## JOINT REGIONAL PLANNING PANEL (Sydney West Region)

<b>JRPP No</b>	2014SYW058
<b>DA Number</b>	DA 1336/2012/JP/A
<b>Local Government Area</b>	THE HILLS SHIRE COUNCIL
<b>Proposed Development</b>	S. 96(2) MODIFICATION TO AN APPROVED MIXED USE DEVELOPMENT
<b>Street Address</b>	Lot E DP 399088, NO. 2-4 BARRY ROAD, KELLYVILLE
<b>Applicant</b>	RESTIFA AND PARTNERS
<b>Number of Submissions</b>	NIL
<b>Regional Development Criteria (Schedule 4A of the Act)</b>	S. 96(2) MODIFICATION TO A DEVELOPMENT EXCEEDING \$20 MILLION
<b>List of All Relevant s79C(1)(a) Matters</b>	<ul style="list-style-type: none"> <li>• LEP 2012</li> <li>• SEPP Sydney Region Growth Centres 2006 (North Kellyville)</li> <li>• SEPP 65 Design Quality of Residential Flat Buildings</li> <li>• SEPP Building Sustainability Index BASIX 2004</li> <li>• SREP 20 – Hawkesbury Nepean River</li> <li>• Residential Flat Design Code</li> <li>• DCP North Kellyville</li> </ul>
<b>List all documents submitted with this report for the panel's consideration</b>	NIL

<b>Recommendation</b>	Approval subject to modified conditions
<b>Report by</b>	Kristine McKenzie PRINCIPAL EXECUTIVE PLANNER

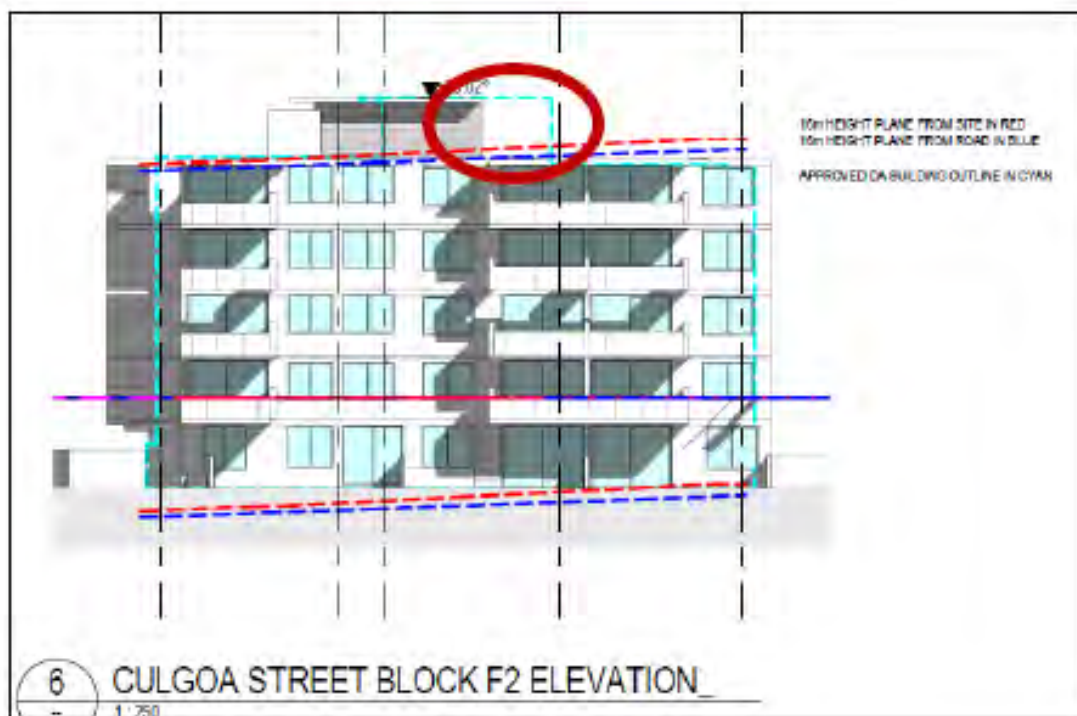
*The plans accompanying the section 96 application do not alter the maximum building heights established under Development Consent 1336/2012. However the amended plans do alter the extent of the building which projects above the 16m Precinct Plan height standard. This circumstance relates only to the rooftop structures associated with mechanical plant and equipment.*

*The extent to which it is proposed to alter these approved rooftop structures is noted below:*

- *Block E - Size increased by 72m<sup>2</sup> to the south to integrate 2 x lift cores, and repositioned slightly to the east;*
- *Block F1 - Size increased by 12m<sup>2</sup>; and*
- *Block F2 - Size reduced by 15m<sup>2</sup> and repositioned slightly to the east.*

*The images below are extracts and highlight the changes to the rooftop plant rooms.*

ATTACHMENT 5 – PROPOSED HEIGHT COMPARISON PLAN

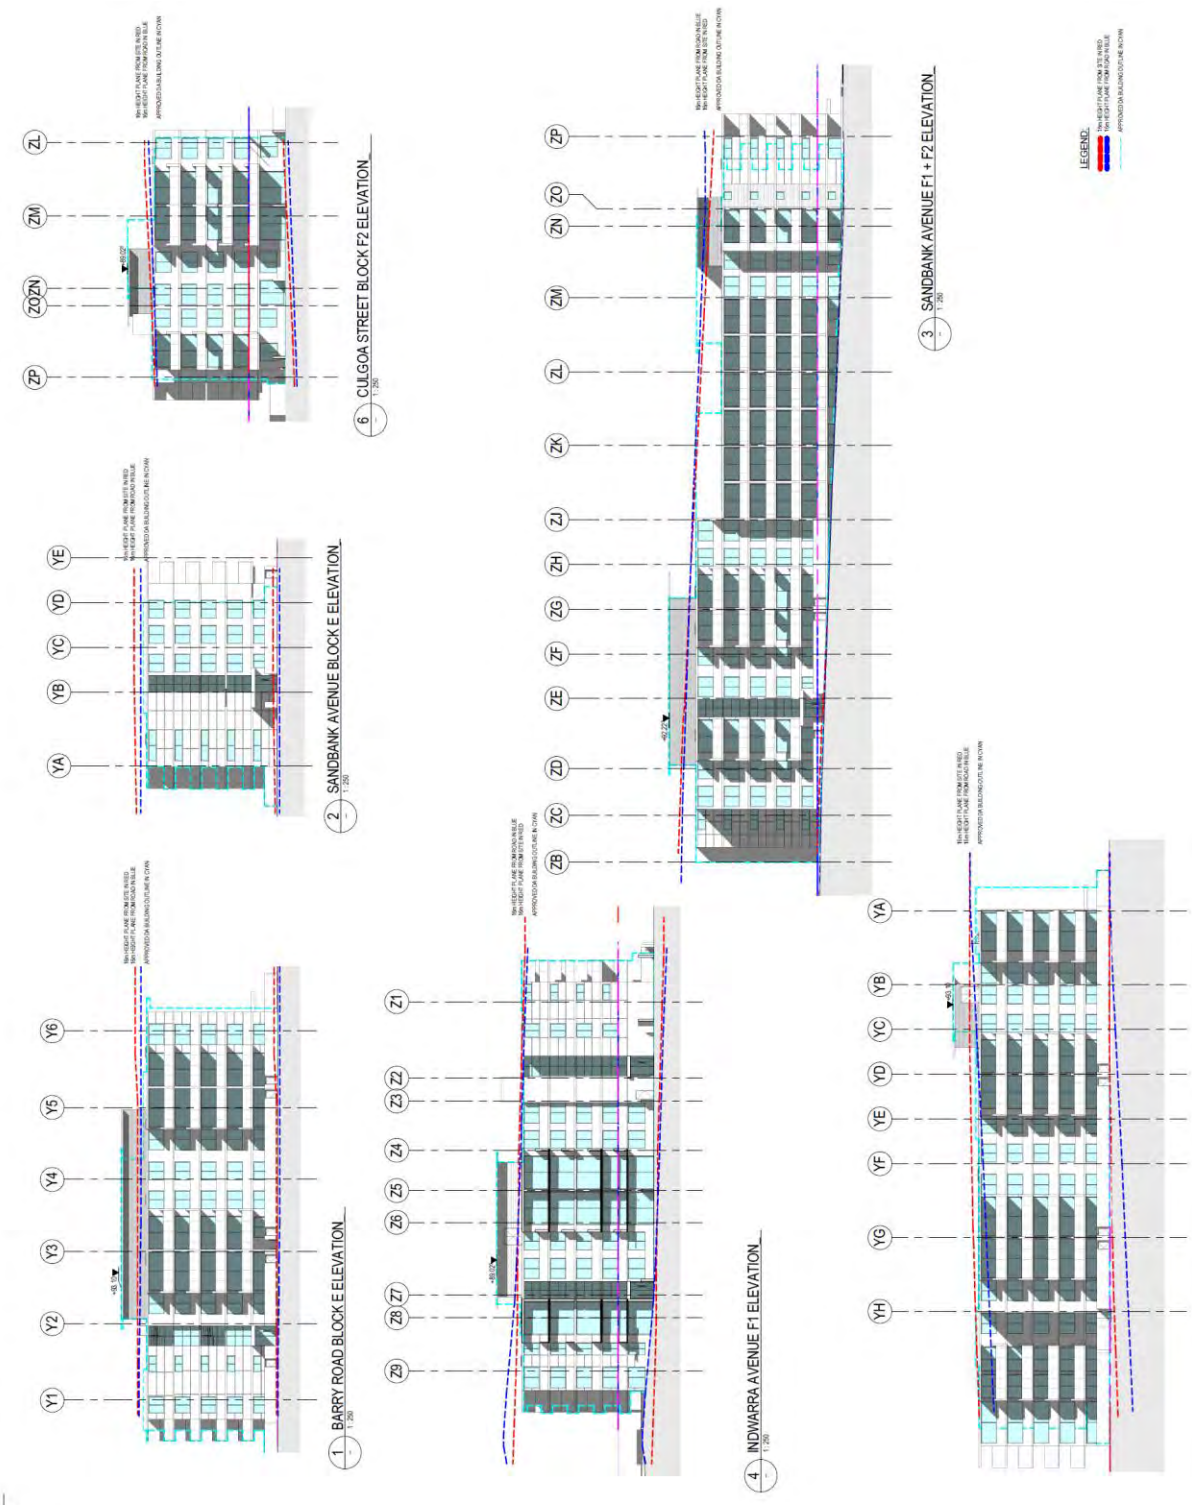
*The proposal does not strictly comply with the maximum height standard prescribed by Clause 4.3(2) of the North Kellyville Precinct Plan.*

*The plans accompanying the section 96 application do not alter the maximum building heights established under Development Consent 1336/2012. However the amended plans do alter the extent of the building which projects above the 16m height standard. This circumstance relates only to the rooftop structures associated with mechanical plant and equipment.*

**Comment:**

Comment: The applicant has adequately addressed the matters required to be addressed by subclause (3).
